Item Name: Replacement Skidtube (Fits LH or RH)

DRAWING NO. D2650	TITLE 206/407 SKIDTUBE ASSEMBLIES	REV. F	DART AEROSPACE LTD ENGINEERING ORDER		D.E.O. NO. D2650-F-1	SHEET NO. SHEET 1 OF 1	SCALE NTS
DRAWN <i>[Signature]</i>	CHECKED <i>A.P.</i>	MFG. APPR. <i>[Signature]</i>	APPROVED <i>[Signature]</i>		DE APPR. <i>[Signature]</i>		
DATE 12.10.12	DATE 12.10.22	DATE 12.10.22	DATE 12.10.22		DATE 12.10.22

PURPOSE:

CHANGE C'BORED WELDED CROSSBOLT SPACERS TO SWAGED SPACERS

DETAIL G

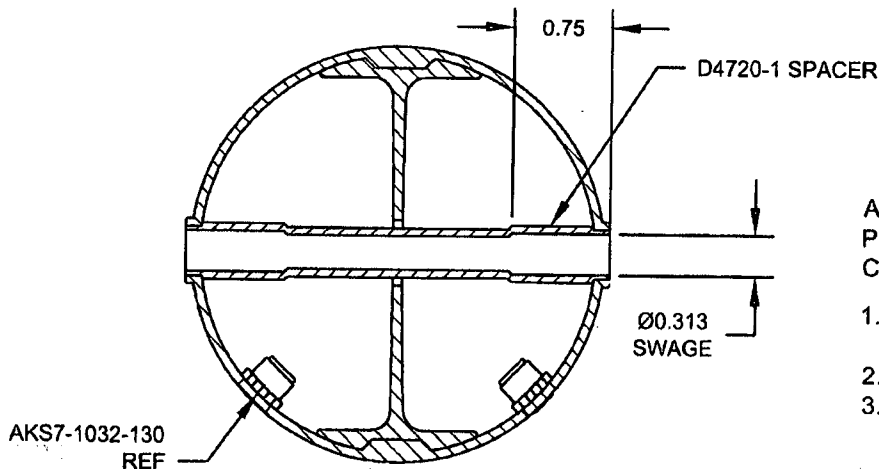
ADD DETAIL G BELOW, WHICH IS THE SAME SECTION VIEW AS DETAIL D OF DWG.
C'BORED HOLES ARE **NOW SWAGED** PER DETAIL G BELOW. FOR THE Ø0.375 HOLE THAT IS NOT C'BORED, WELD PER DETAIL D OF DWG (SEE AMENDED DETAIL B FOR REFERENCE).

FOR Ø0.375 HOLES ONLY
FOR HOLES THAT ARE CURRENTLY C'BORED ONLY
NOT TO SCALE
